UNITED STATES PATENT AND TRADEMARK OFFICE

APPLICATION NO.	FILING DATE	FIRST NAMED INVENTOR	ATTORNEY DOCKET NO.	CONFIRMATION NO.
10/004,758	12/04/2001	Donald J. Monroe	10541-636	8286
29074	7590	01/19/2005	EXAMINER	
VISTEON C/O BRINKS HOFER GILSON & LIONE PO BOX 10395 CHICAGO, IL 60610				RODRIGUEZ, PAMELA
		ART UNIT		PAPER NUMBER
		3683

Office Action Summary	Application No.	Applicant(s)	
	10/004,758	MONROE ET AL.	
	Examiner	Art Unit	
	Pam Rodriguez	3683

DETAILED ACTION

Fig. 1

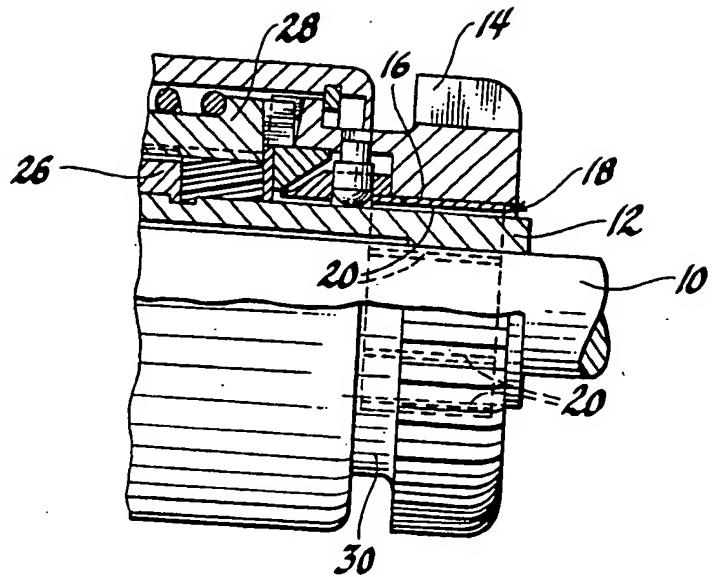
Regarding Claim 1, Johnston discloses a pinion 14/18 moveable along an output shaft 10 of a starter assembly (see Figures 1 and 2) having all the features of the instant invention including: the pinion 14/18 having an inner surface 24 disposed about the output shaft 10 (see the new attached labeled Figures 1 and 2 of Johnston and the inner surface portion indicated therein, wherein since bushing 18 is integral with pinion 14, the inner surface is readable as the inner surface 24 of pinion bushing 18), the inner surface terminating at an end face of the pinion 14/18 (see the examiner's attached labeled Figures 1 and 2 of the Johnston reference depicting the inner surface and the end face as she now interprets them), wherein the inner surface and the end face are perpendicular with each other and define a secondary edge (see the examiner's attached labeled Figures 1 and 2 of Johnston, where the secondary edge is now more clearly indicated), wherein the pinion 14/18 comprises a primary edge (see Figure 2 and the middle groove 20, wherein the primary edge is readable as the right top edge of that groove nearest the top lead line of element numeral 24) for moving particles from the

Regarding Claim 14, see the barrel portion shown in Figure 1 and a gear portion (see Figure 1 and the portion of pinion 14/18 labeled element numeral 14), wherein the end face and the inner surface 24 are adjacent the gear portion (see Figures 1 and 2).

Fig. 2

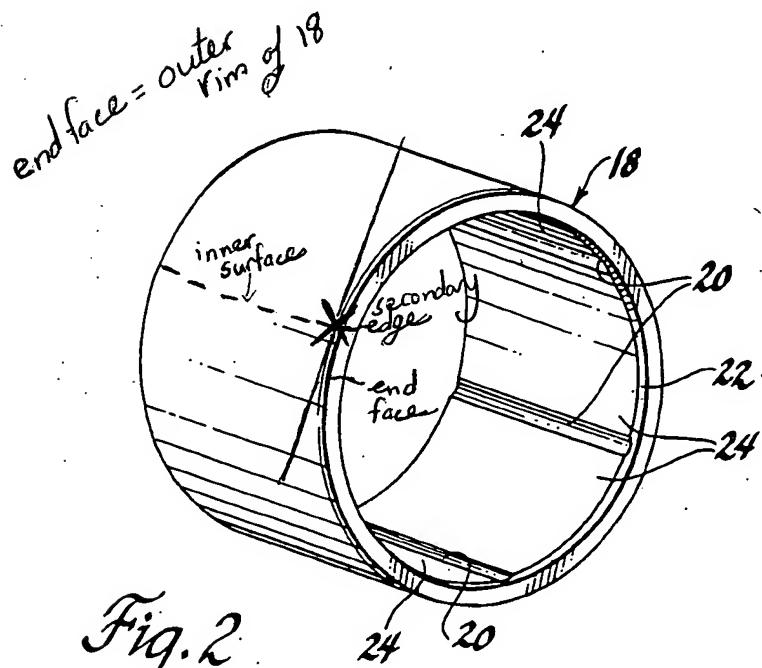
shaft 10 as the pinion 14/18 moves along the output shaft (see column 3 lines 6-13), the primary edge being formed along a length of the inner surface (see Figure 2) and extending to the end face (see Figure 2), the primary edge defining a groove 20 in which the particles are received as the pinion 14/18 moves along the output shaft (see column 3 lines 6-13), and wherein the groove 20 is formed along the length of the inner surface 24 and adjacent the primary edge (see Figure 2).

Regarding Claim 5, Johnston further discloses a secondary edge for moving the particles from the primary edge, the secondary edge being defined at the juncture of the end face and the inner surface and being configured to move the particles from the shaft (see the examiner's attached labeled Figures).

Regarding Claim 9, see the plurality of grooves 20 on the inner surface 24 shown in Figure 2 and note how each groove has its own separate primary edge as described in Claim 1 above.

Regarding Claim 10, see grooves 20 in Figure 2, each formed along the length of the inner surface 24 and adjacent each respective primary edge.

Firstly, the examiner wishes to apologize for the Figure 2 drawing of the Johnston reference submitted to applicant. The office merely made a photocopy of the examiner's color-coded drawing instead of sending out the original, color copy as they were instructed. The examiner has since re-submitted this Figure 2 drawing in black and white labeled form with this office action as she originally interpreted it, to better clarify her position.

Thusly, as more clearly outlined in the rejections above and the new depiction of the Johnston Figure 2 drawing newly re-labeled, the examiner has better defined the inner surface, end face, and secondary edge portions of the Johnston reference as she interprets them. When Claims 1 and 15 are read in light of these defined elements, the Johnston reference still meets the limitations of the claims.

In response to applicant's arguments directed towards his statement of two surfaces not being perpendicular with each other merely because a line drawn along the first surface is perpendicular with a line drawn tangent to the arc of the second surface, the examiner contends that applicant's remarks are more specific than his claims. On this point, applicant merely claims that the inner surface and the end face are "perpendicular". The claim provides no means of limiting or defining how or in what plane of orientation this perpendicularity must exist. Therefore, the examiner's drawing

showing how a perpendicular relationship exists in the reference of Johnston can still meet the limitations of the claim.
